Video Products Technical Bulletin 30-2015-102R

SUBJECT: **PARTS REGISTRATION—Q BOARD, B BOARD,
AND CONNECTOR-RELATED PARTS**

LMD-1530MC
LMD-1530MD
LMD-1951MC
LMD-1951MD
LMD-2110MC
LMD-2110MD
LMD-2451MC
LMD-2451MD
LMD-3251MT
LMD-3251SC
LMD-3251ST
LMD-3251TC
PVM-2551MC
 PVM-2551MD

Figure 1

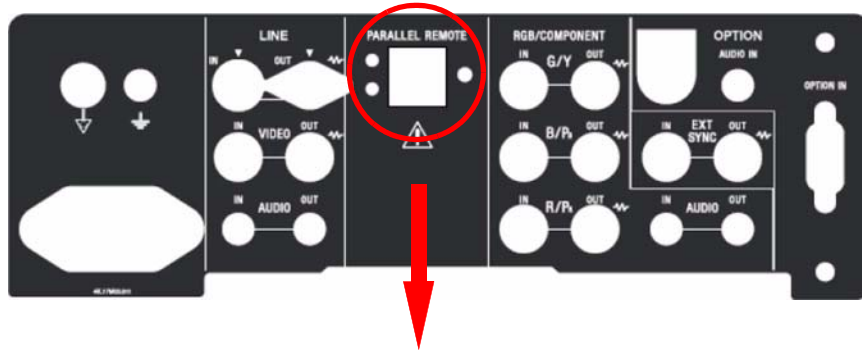
- Former and new boards are not compatible; when replacing a former with a new board, replace the connector-related parts listed in Table 1 as well.
 - The new connector cover and connector bracket are compatible with both former and new boards.
 - The new boards have different-sized parallel remote connectors. To distinguish between former and new boards, refer to Figures 1 and 2 on pages 3 and 4.
-

CONNECTOR LABEL

FORMER (4-256-828-11/21)

NEW (4-256-828-12/22)

Figure 2

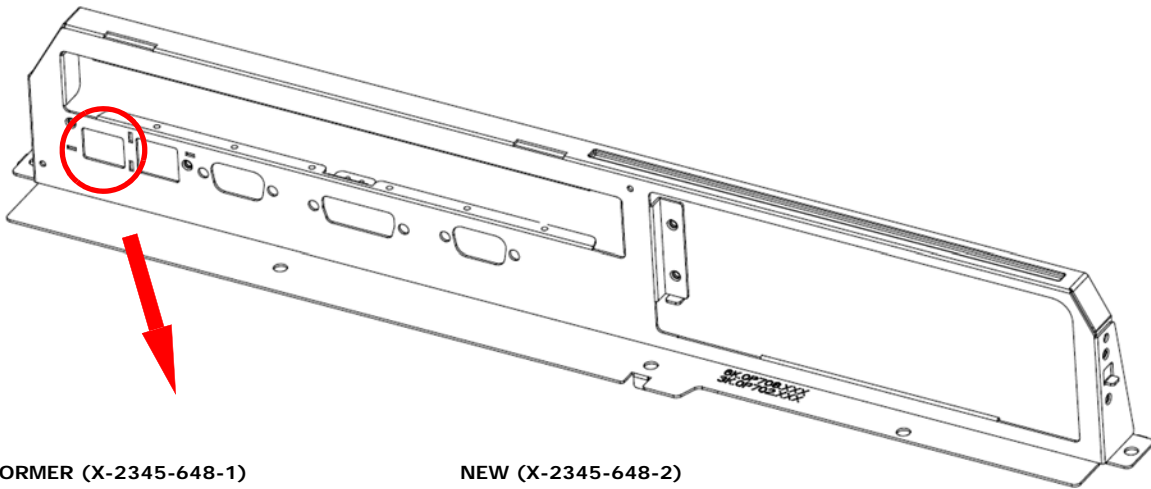
CONNECTOR PLATE
X-2345-648-1/2

FORMER (X-2345-648-1)

NEW (X-2345-648-2)
